CDV-700 RADIOLOGICAL SURVEY METER
PROTECTIVE DIODES AND CAPACITORS

The procedures contained in this document are for the implementation of these circuit modifications.

Figure 6-4. Location of Test Points

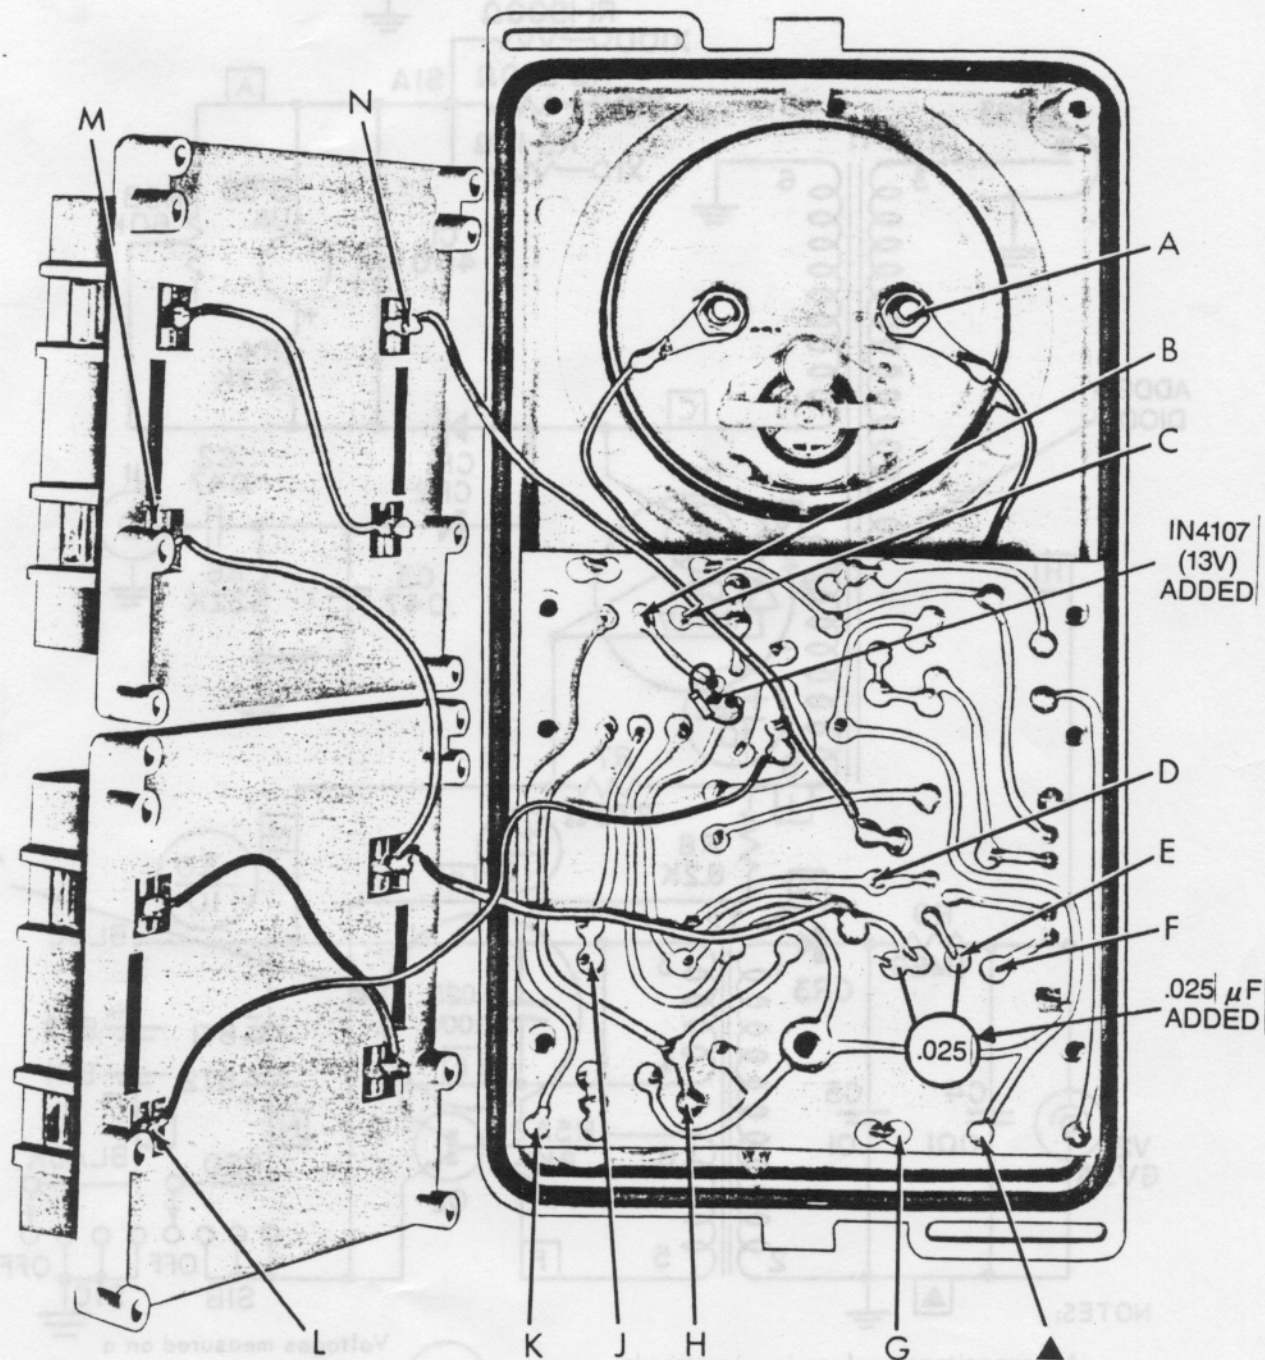
1. Install one ea. 1N4117 Diode (21103) between the emitter to collector circuit of Q1 in the Victoreen V-700-6 and 6A. Also, one ea. .05uf capacitor (21113) across winding 3 & 4 of transformer T2 (see attachment).
2. Install one ea. Zener diode 1N4107 (21104) across the emitter to base circuit of Q1, and install one ea. capacitor .025uf (21115) across winding 3 & 4 of T2 (see attachment).
